NOTICE OF PUBLIC MEETING CITY OF MILLERSBURG PLANNING COMMISSION

Wednesday, June 13, 2018
6:00 p.m.

Proposal: The City of Millersburg is proposing to construct a fire station on 1.82 acres. The station and site improvements will include approximately 0.5 acres, located entirely within the area that has been cleared of wetland constraints. The remainder of the site will remain undeveloped. The station will consist of a 1836 sf modular building with four bedrooms and three bathrooms and a 1296 sf portable bay. The modular building will be used as sleeping quarters and office space for two to three emergency response personnel. The portable bay will be used to house response equipment. Site improvements include two new 24' wide driveways off Conser Road, asphalt pavement for all vehicular and parking areas, and a 15' landscape buffer along Conser Road. Seven parking spaces will be provided. Landscaping will consist of grass areas around the perimeter of the developed space.

Project Description

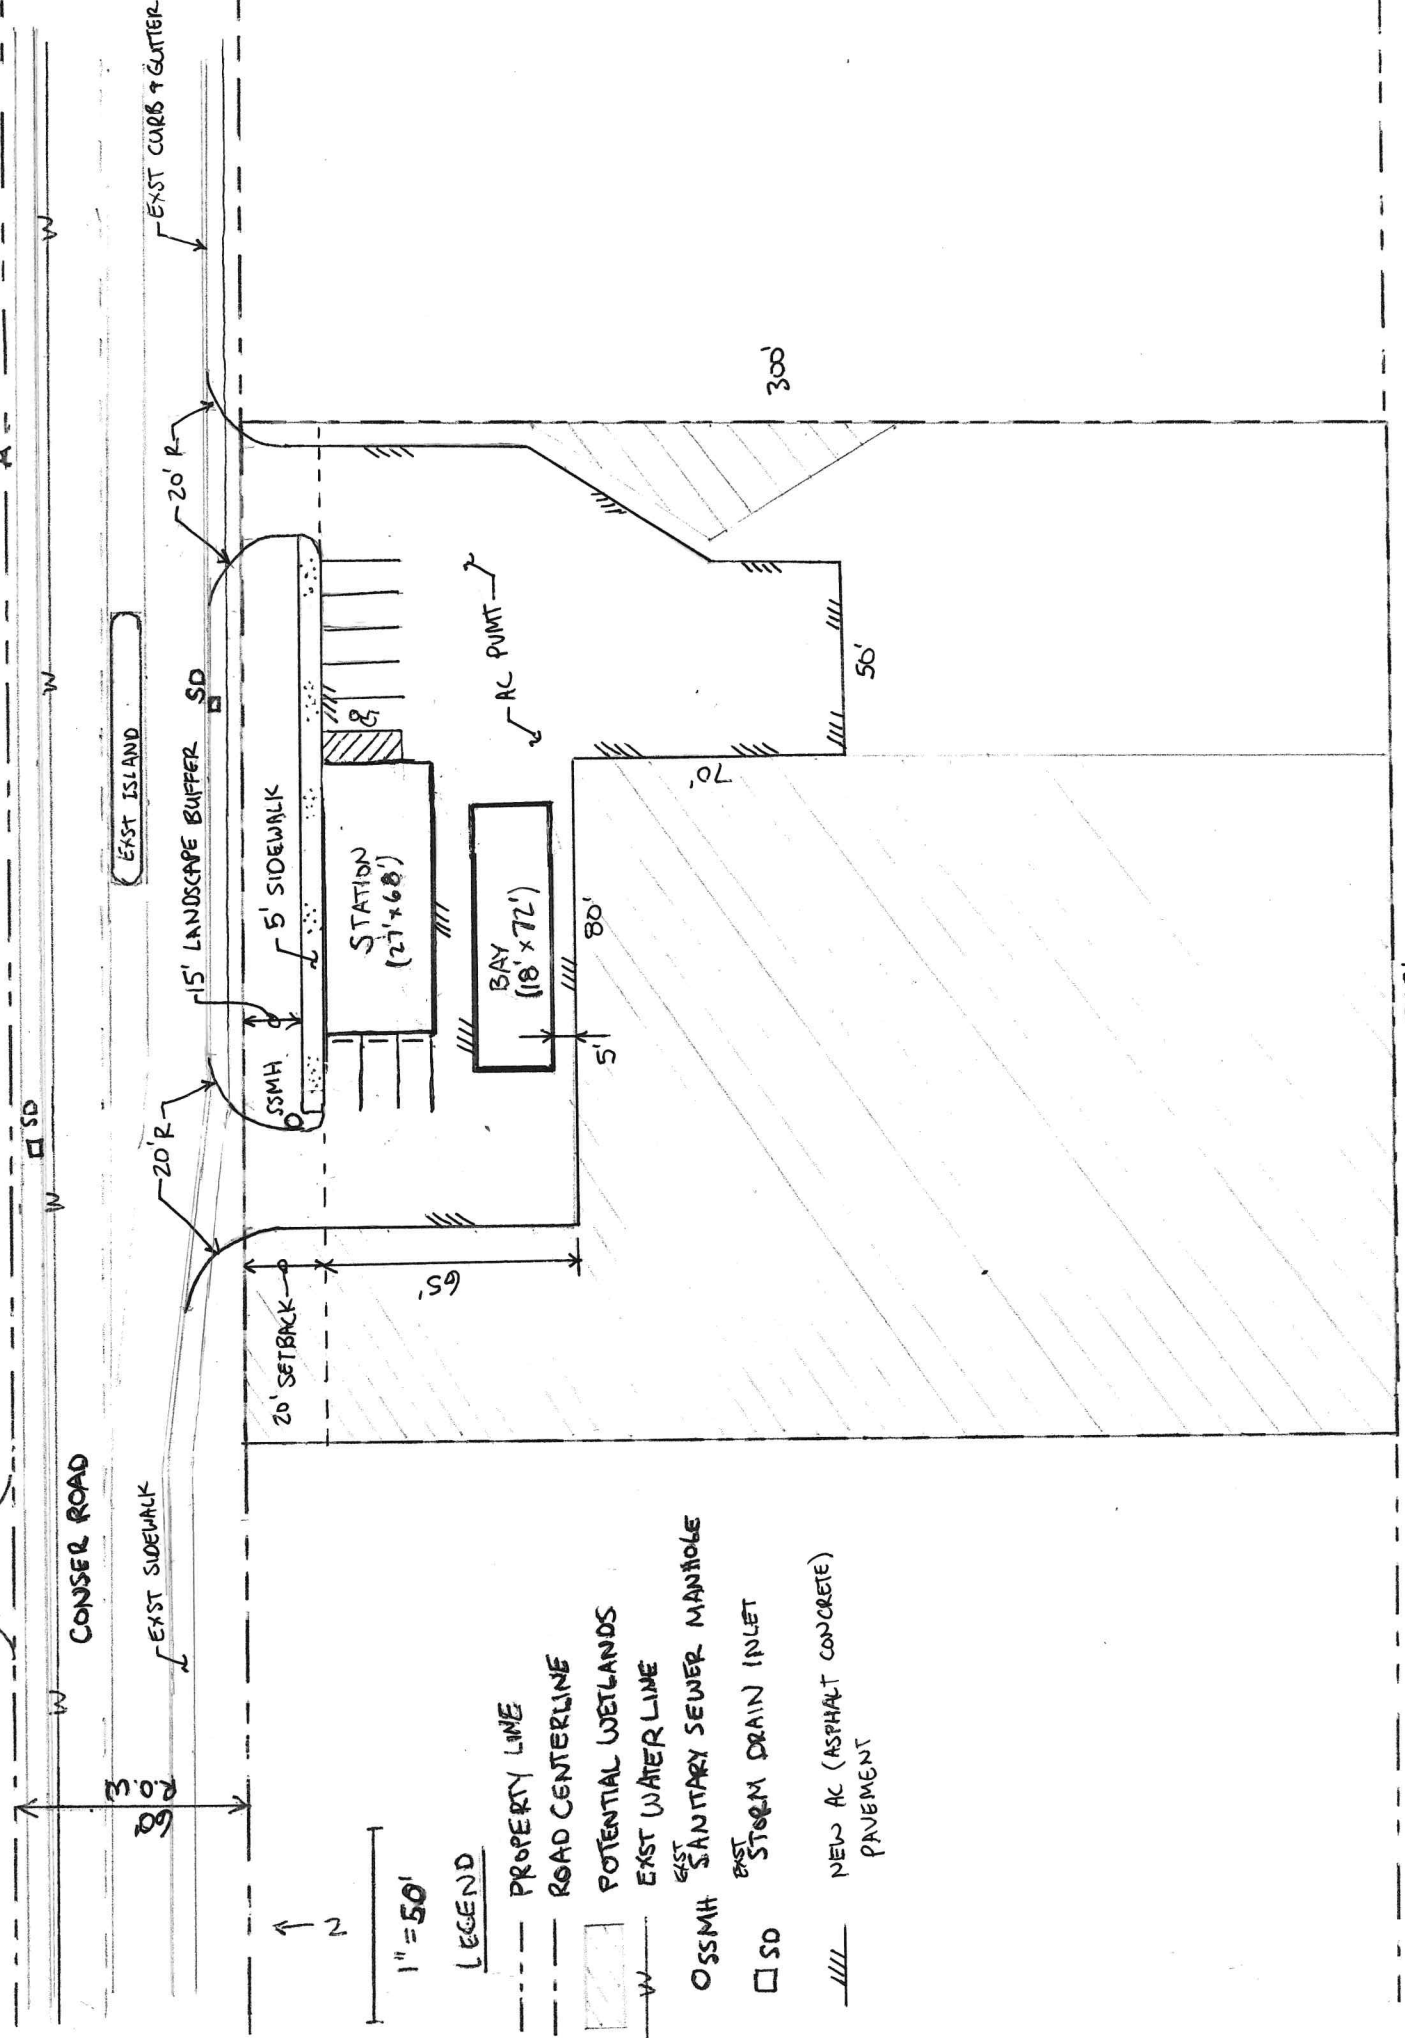
ANALYSIS: A buffer is required on the east side as the zone changes at the property line. A space is shown on the plans that could accommodate the required landscape area however no landscape plan was provided. The required 12-foot buffer from the street is shown on the plans.

PROPOSED CONDITION OF APPROVAL: The landscape plans to be submitted shall include a 5 foot landscape buffer, complying with the requirements of Section 5.122, including screening, on the east side of the development. The buffer need not run the entire parcel length, rather the buffer is only needed 185' from the street as that's the length of the proposed development.
